8. Well Name and No.
KURLAND 6 FEDERAL 2

REF: KURLAND "6" FEDERAL No. 2 / Well Pad Topo

UNITED STATES
DEPARTMENT OF THE INTERIOR
BUREAU OF LAND MANAGEMENT
NOTICE OF INCIDENTS OF NONCOMPLIANCE

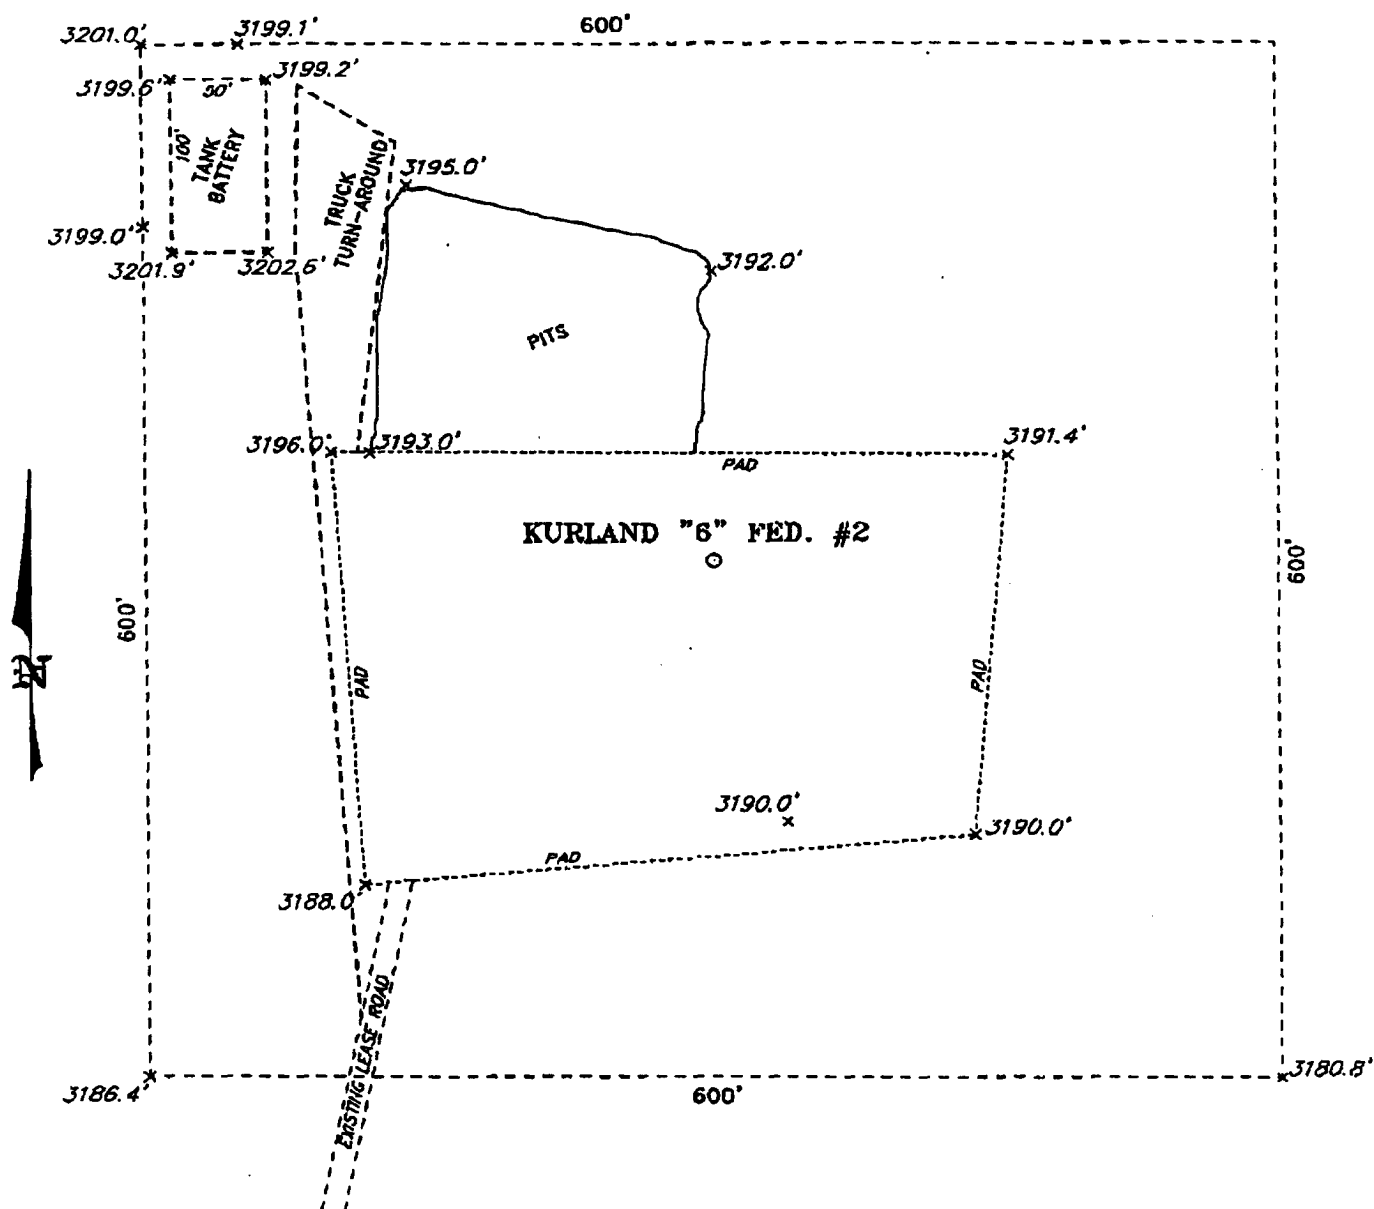
Devon Energy Productin Company, LP respectfully requests a 30 day extension of time (until July 20, 2004) to comply with the Notice of Incidents of Noncompliance dated 05/19/04 regarding the location of the tank battery below the 3200' contour elevation. Attached is a plat that indicates the new location of the tank battery. Any part of the proposed location not at 3200' or more will be built up to ensure that all areas of the proposed pad are located at or above 3200' contour elevation.

LEASING STIPULATIONS AND REQUIREMENTS FOR THE SUBJECT RECLAMATION MANAGED LANDS ARE AS FOLLOWS
NO SURFACE OCCUPANCY BELOW CONTOUR ELEVATION 3180.
NO STORAGE FACILITIES BELOW CONTOUR ELEVATION 3200.
YOUR WELL ELEVATION SHOWS TO BE 3188, IF THE CONTOURED ELEVATION OF YOUR WELL AND FACILITIES IS
ABOVE 3200 FEET GIVE DOCUMENTATION SHOWING THIS.
(2) APPLY FOR THIS FACILITIES USING A 3180-S SUNDRY FORM.

APPROVED FOR 1 MONTH PERIOD
ENDING 7/20/04
